Re: Eagle Gold Mine site – HLF Operations and Cyanide Management Desktop Review

In 2022, Mineral Resources Branch (MRB) retained a third party to conduct a review of Victoria Gold (Yukon) Corp's (VGC) operation of the heap leach facility and cyanide management at the Eagle Gold Mine. Mark Smith of Piteau Associates USA Ltd. was responsible for this review, and completed it by way of a desktop study. VGC had several opportunities to provide input throughout the process, including a review of draft technical memos and recommendations. The final report, issued on July 31, 2022 and provided to VGC on September 26, 2022, has taken into consideration the input received throughout the process. For completeness and ease of reference, the final report has been appended to this letter.

Appendix 1: Implementation Expectations

Figure 4-1: ADR Infrastructure Layout

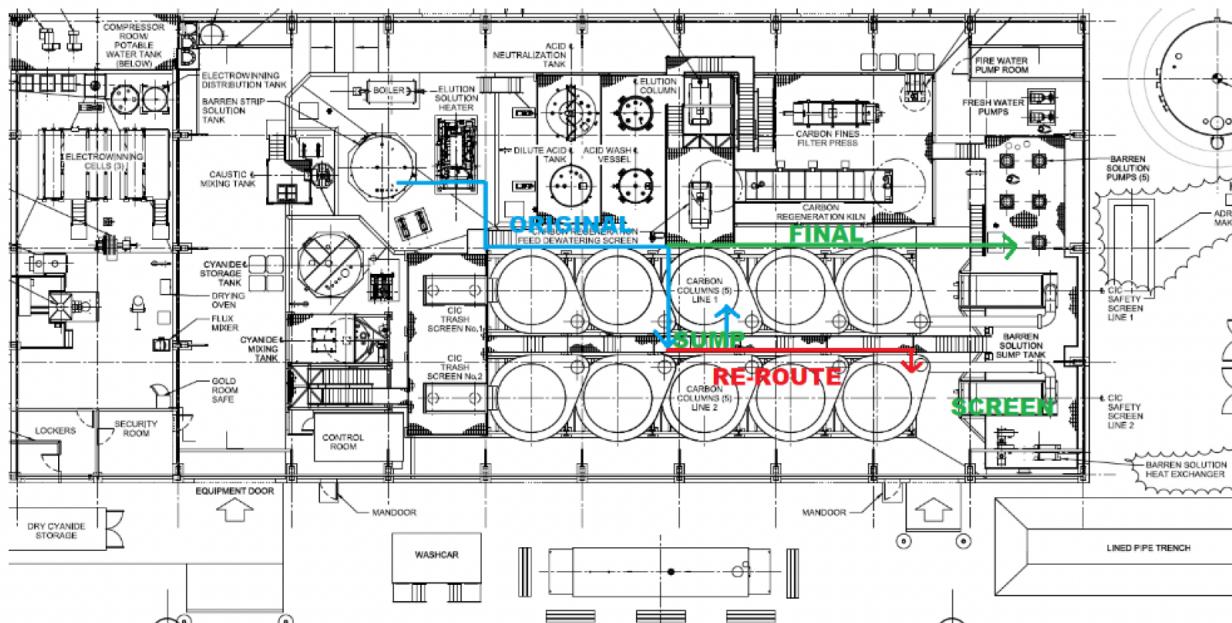
There was a process solution release from the ADR plant on 22 June 2021 (Eagle Gold Project Spill Report, July 2, 2021). This was the third reported spill but the first related directly to the ADR plant. The Root Cause analysis presented in that report identified as the primary root cause *“a change in the routing of process solution, which enabled the introduction of warm caustic barren strip to the tail end of the south CIC train.”* This, in turn, contributed to the formation of precipitate which blinded the fine discharge screens and allowed process solution to overflow onto the ADR plant floor and, ultimately, exit the plant through the ADR southeast bay door (see Photo 1, below, which is an excerpt of Photo 2-1 of the referenced spill report). Figure 4-1, also from that spill report (reproduced below), shows the original and re-routed flows.

Since moving pipes and clogged screens are common in ADR plants, this does not seem to address the actual root cause. The area where the spill occurred was within the ADR plant, but the containment was inadequate to hold this spill. This is in contrast with Section 4.1 of the Forte report (page 14) which states *“Any spillage within the ADR plant are contained within the process plant containment.”* Since any part of an ADR plant can be exposed to process solution the primary root cause is the lack of adequate containment, which was missed in the audit.

2.1a: The ADR plant should be retrofitted to provide adequate containment as described in the CMP and the ADR Plan, or otherwise as intended by the Cyanide Code and best industry practices. This retrofitting should include measures adequate to ensure full containment. The retrofitting as envision in this recommendation should be relatively minor work. This should be completed in 2022.

2.1b: The CMP and ADR Plan should be updated to reflect current conditions.

Figure 4.2-1: Cyanide Storage and Mixing Area Containment

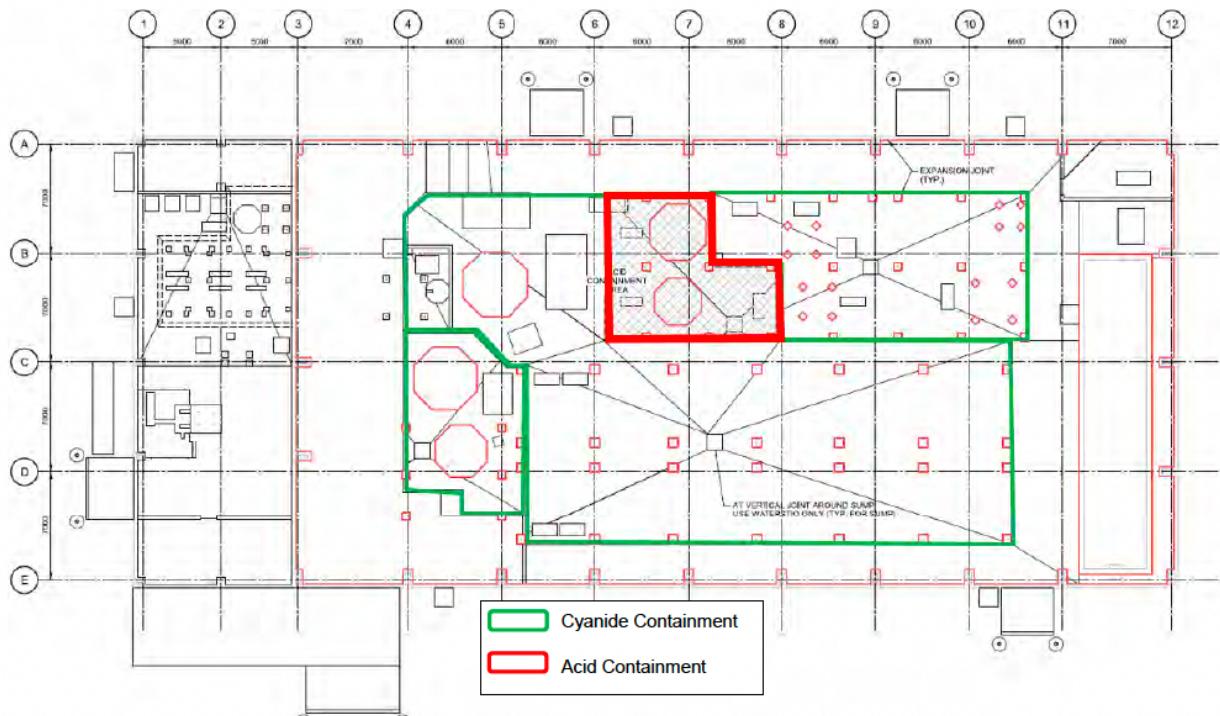
Figure 4.2-1 of the CMP (reproduced below) shows the area of “cyanide containment” as essentially the entire ADR plant (the green outline) including the area of the spill. Section 5.7.5 states *“Process solution pipelines within the ADR area are all installed within concrete secondary containment. All barren solution risers and distribution lines will be placed within the lined footprint of the HLF, thus any potential leakage is captured within the pad, ultimately reporting to the In-Heap Pond. The pregnant and barren solution pipelines to the HLF riser arrangements and associated pumping stations that do not drain directly to the HLF impoundment will be placed in lined trenches, with any leakage, stormwater, or snowmelt accumulation in the liner system reporting to either the HLF impoundment.”* Section 2.2 of the ADR Plant Operations Plan (ADR Plan) (StrataGold, March 2019) states *“Beyond concrete containment with the building, The ADR Plant itself rests on pad also designed for cyanide containment. The pad underneath the building is lined and graded such that overflow would be directed into a lined trench that flows back into the Heap Leach Facility (Figure 2.2-2).”* Figure 2.2-2 of the ADR Plan is also reproduced below.

Section 4.2 (Contributing Factors) of the spill report states *“Two main site factors have been identified that contributed to the subsequent release of process solution outside of ADR containment: 1) ADR containment design considers only overflows from defect or damage to the tankage within the ADR (as is common for secondary containment design), 2) pad and road*

grading allowed process solution to escape containment rather than flow to the heap pad.” Item #1 accurately represents the as-built condition of the ADR plant but is inconsistent with the Forte report, the CMP, and the ADR Plan. Importantly, items 1 & 2 are not in compliance with Cyanide Code Standard of Practice 4.1, which states “*Implement management and operating systems designed to protect human health and the environment including contingency planning and inspection and preventative procedures.*” That is, since the ADR plant can have process solution anywhere, the plant should include full secondary containment. Further, any potential escape routes from the in-plant containment should be directed towards external containment.

Figure 5.3-1: Site Water Balance Model

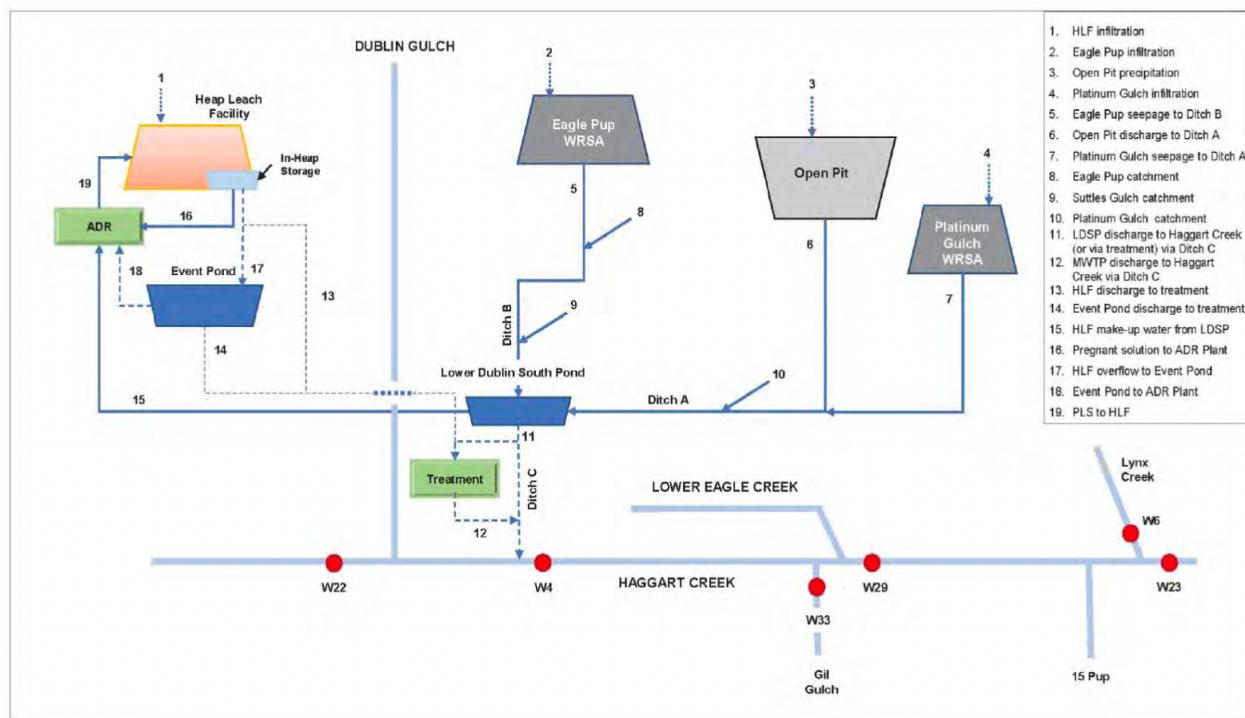
The water balance model is the subject of a separate technical memo, but since water balance management is discussed in the CMP (Section 5.3), some specific related issues are pointed out here. This section includes a schematic of the model as Figure 5.3-1, reproduced below. However, there is an important connection missing: water from the Lower Dublin South Pond (LDSP) is periodically pumped to the Events Pond (EP) to avoid discharging non-compliant water from the LDSP. Surplus surface water thus accumulated in the EP is occasionally discharged from the process circuit without treatment (i.e. #14 of Fig. 5.3-1, but not to treatment). Neither of these flows are reflected in the water balance model and that has contributed to extended periods of infringement on the Desired Available Storage (DAS) in the Events Pond during 2020 and 2021. A minor issue is that the diagram identifies the flow from the ADR to the HLF (#19 of Fig. 5.3-1) as "PLS to HLF." This is not usually PLS but rather barren solution.

The transfer of solution from the LDSP to the EP is contrary to the language of CMP Section 5.4.1 Prevention Measures for Open Ponds, which states "*The Events Pond will be maintained empty except to contain and temporarily store exceptional rainfall events or overflows from the in-heap pond.*" However, such exclusiveness in terms of use of EP is in the context of protecting wildlife, and so long as the EP has never been used to store process solution the risk to wildlife from these transfers should be minor.

Figure 5.3-1 – water balance model	The water balance model depicted is for the entire site. The HLF-specific water balance model is more directly applicable and should be included. This will also reduce the	The site water balance model report and schematics include all necessary detail about the management of HLF water/solution and how site water management is integrated with MWTP operations. Thus, while VGC is not	An updated CMP will be provided in Q1 2024.

2.3a: Update Sections 5.3 and 5.4 of the CMP, including Figure 5.3-1, to reflect the current water management system, including flows directed from the LDSP to the EP and discharges from the EP. This should occur with the next CMP update.

2.3b: Protocols should be developed for transfers of storm water to the EP to verify that there is no cyanide in the EP so that the intent of Section 5.4.1 is not violated. This should be revised in the next CMP and EMSAMP updates.
